Applicant : Nguyen et al.
Serial No. : 10/778,013
Filed : February 11, 2004
Page : 14 of 16

Attorney's Docket No.: 13854-062001

Amendments to the Drawings:

Fig 7

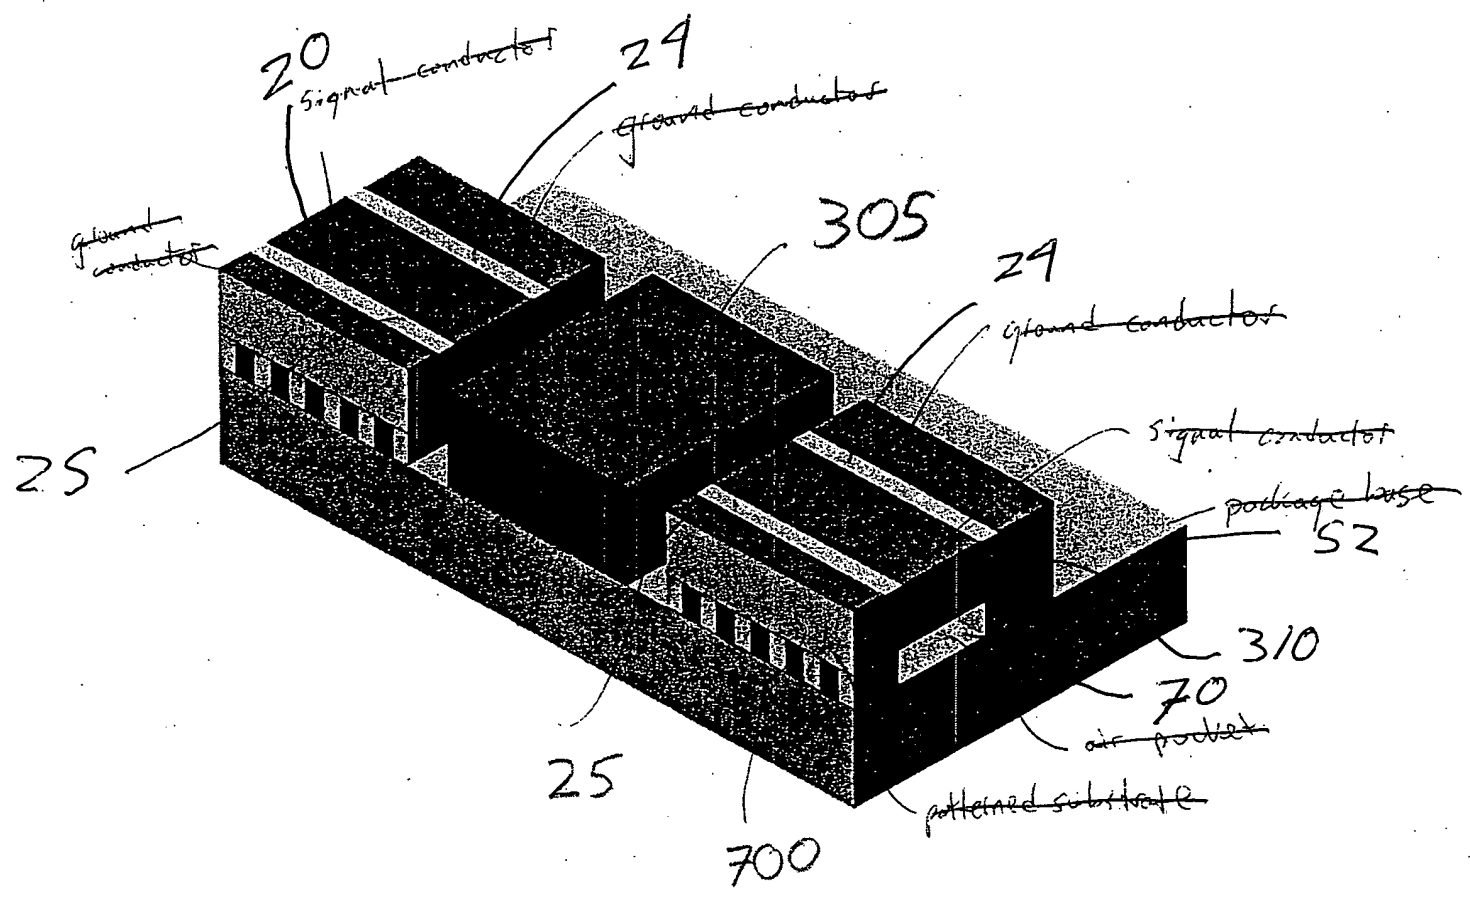
The attached replacement sheet of drawings includes changes to Fig. 7 and replaces the original sheet including Fig. 7.

In Figure 7, descriptive language as been deleted and reference numerals 20, 24, 25, 52, 70 and 310 have been added.

The Examiner has pointed out numerous informalities regarding the specification and Figure 7. Applicant believes these informalities have been corrected with the included amendments to the specification and the replacement drawing sheet including correction of Figure 7. No new matter has been added.
